ADDENDUM #5

Project	Pope Francis Elementary School	Project #	pf1701
Location	387 Balsam Street North Timmins, Ontario	Date	June 21, 2017
		Pages	1 of 5

Pope Francis Elementary School Addition & Renovation
387 Balsam Street North
Timmins, ON

M&E Addendum No. 2

ROOF PLAN
HVAC LAYOUT
M2.5

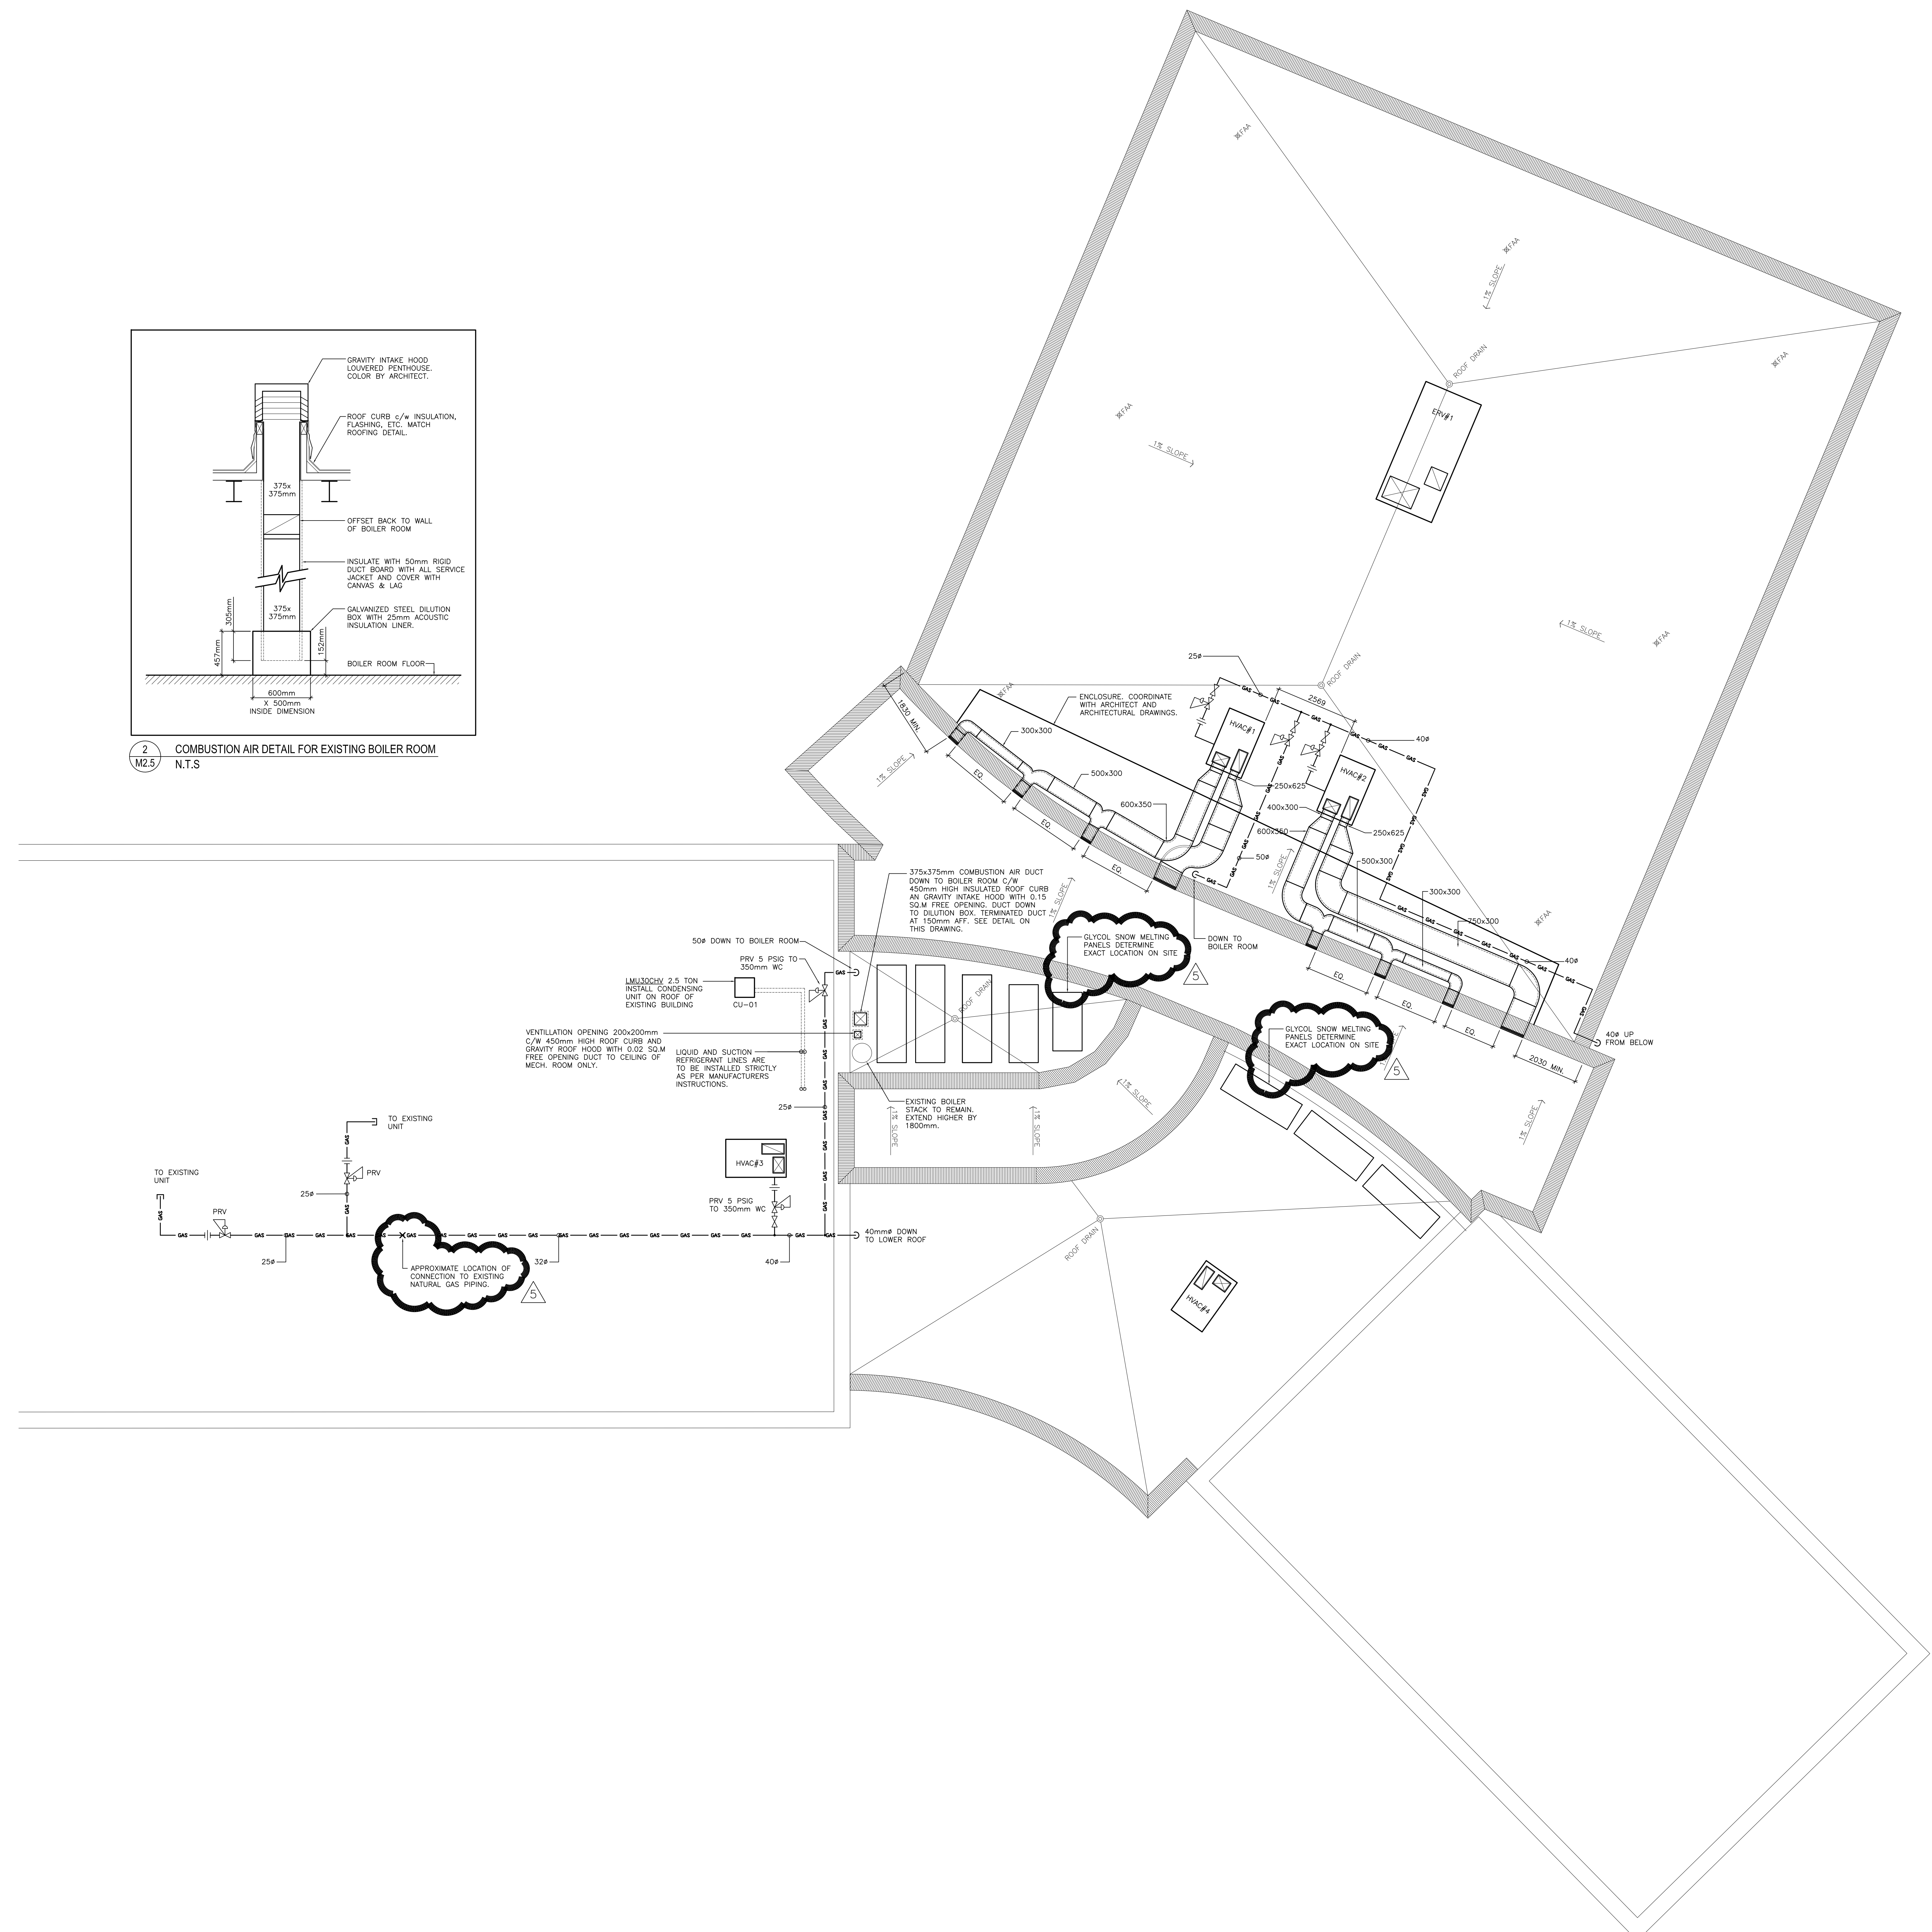
- 13.1. Glycol snow melting system and panels to be as per layout and specifications shown on drawing M2.5. Snow melting system is to be controlled by the existing BAS.
- 13.2. Refer to attached drawing M2.5 Rev. 5. This drawing shall replace drawing M2.5 Rev.4 issued with M&E Addendum #1.
